<i>Recall Bulletin</i>	<i>RCL-05-001</i>
	<i>DNA</i>

***Subject:* Front Brake Line Retaining Clip**

***Models:* 999/999S M.Y. 2003 and 749S M.Y. 2003**

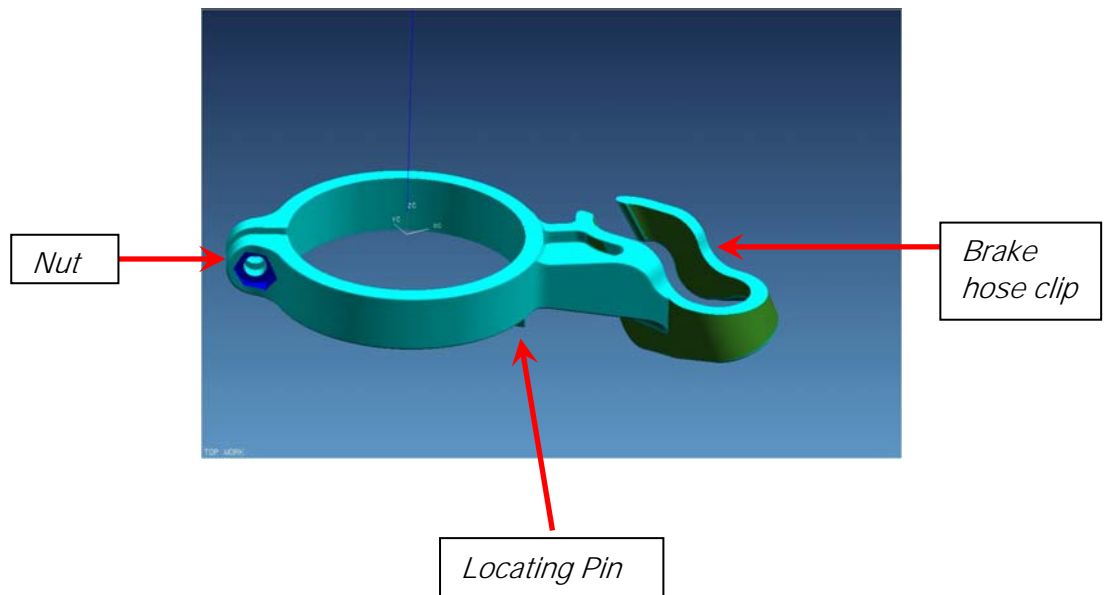
Ducati Motor S.P.A. has determined that it is possible that the front brake hose will become trapped between the lower steering flange and the steering lock peg when the vehicle is cornering. This condition could cause a loss of front brake fluid pressure and damage to the brake hose, which consequently could rupture, causing front brake failure. This condition can cause a vehicle crash without prior warning.

Fit retaining clip part number 74110301A for models 999 and 749S, and retaining clip part number 74110301B for models 749S to the RH fork leg, just above the lower steering flange. For all models described above, secure clip with screw part number 60N107330 and retaining nut part number 74950021A. Tightened nut must be flush with the clip (See picture attached). Slide the front brake hose through the open end of the clip.
